GP COMPANIES, INC.

Subject: MW/MWR LP Inlet Cover Bolt Update

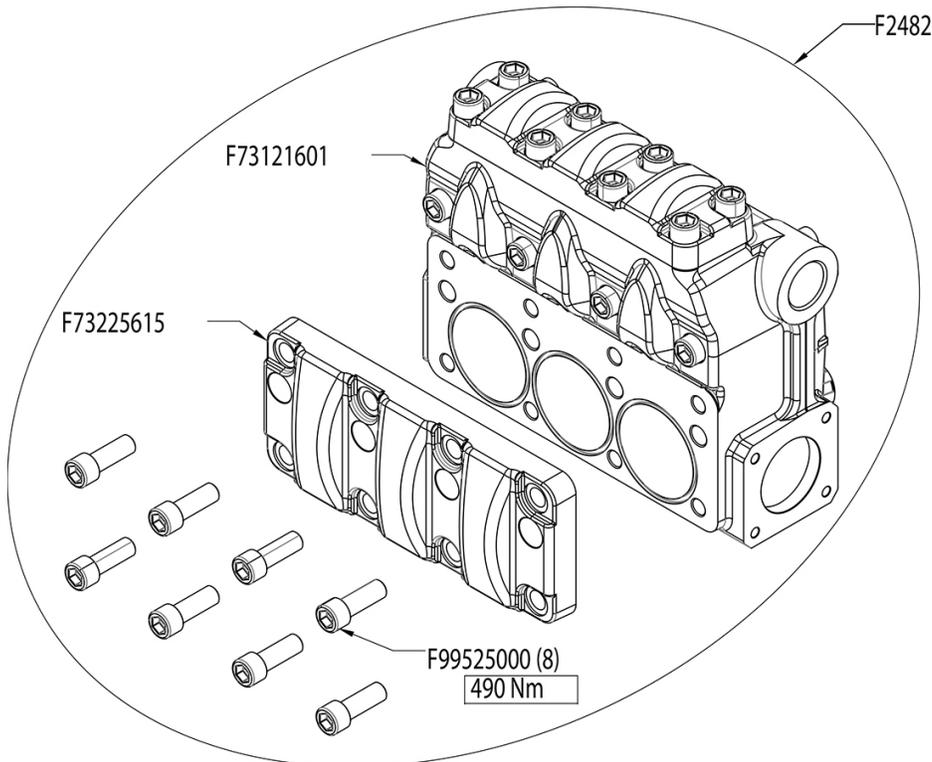
Effective from serial code 19177007 and on, all MW Low Pressure Pumps (MW45-50-55 (incl. "R" & "S" types) will feature M18 bolts instead of previous M16 to retain the Inlet (Suction) Cover. This improvement requires the manifold and valve cover to change; part numbers to retrofit are noted below.

If a new manifold is required on any pumps with serial code 19177007 or older, please use the conversion kit:

F2482 → Conversion Kit: Includes Manifold, Inlet Valve Cover, and M18 Bolts (QTY 8)

F73121601 → New Manifold Only (Previous PN F73120315)

F73225615 → New Inlet Valve Cover Only (Previous PN F73210815)

F99525000 → New M18 Bolts (Qty 8 Rq'd)

Tightening torque of the new M18 bolts is 490 Nm (361 ft-lbs)
